Access Compliance Report

Public Rights-of-Way

Intersection ID: 25834	Main Street: PARK_RD	Cross Street: OSPREY_DR	Location: W
ADA ID: 98CB869BA9C0	Ramp Type: PerpDiag	Initial Pass/Fail: Pass	Overall Compliance: No
		Severity Score: 12.5

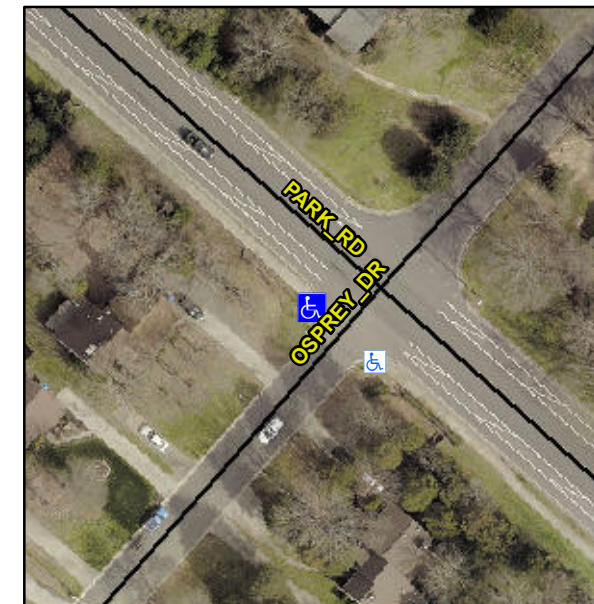
Not Found, R304.2.1, R304.2.2-Perp, R304.3.2-Para, R304.5.3, R305.1.4, R305.2

Compliance	Description	Data	Compliance	Description	Data
N/A	Ramp Length (in)	70.0	Yes	Ramp Slope (%)	7.8
Yes	Ramp Width (in)	48.0	Yes	Ramp XSlope (%)	1.4
N/A	Flare Type LT	Sloped	N/A	Flare Type RT	N/A
N/A	Flare Slope LT (%)	7.0	Yes	Flare Slope RT (%)	9.0
N/A	Flare Traversable LT?	Yes	N/A	Flare Traversable RT?	Yes
No	Landing Length (in)	N/A	Yes	DWS Provided?	Yes
No	Landing Width (in)	N/A	Yes	DWS Contrast?	Yes
No	Landing Slope (%)	N/A	Yes	DWS Length (in)	24.5
No	Landing X Slope (%)	N/A	No	DWS Full Width?	No
N/A	Landing Curb? (Y/N)	No	No	DWS Offset (in)	2.5
N/A	Shared Landing?	N/A			
Yes	Gutter Ponding?	No	Yes	Gutter Slope (%)	1.3
Yes	Gutter Lip Ht (in)	0.0	Yes	Gutter X Slope (%)	0.8
N/A	Painted X Walk1?	No	N/A	Painted X Walk2?	No
	X Walk 1 Direction	To SE		X Walk 2 Direction	To NE
N/A	X Walk 1 Width (in)	N/A	N/A	X Walk 2 Width (in)	N/A
	X Walk 1 Slope (%)	0.3		X Walk 2 Slope (%)	1.7
	X Walk 1 X Slope (%)	0.0		X Walk 2 X Slope (%)	1.9

Remove & Replace Curb Ramp With Two New Directional Ramps or Equivalent.
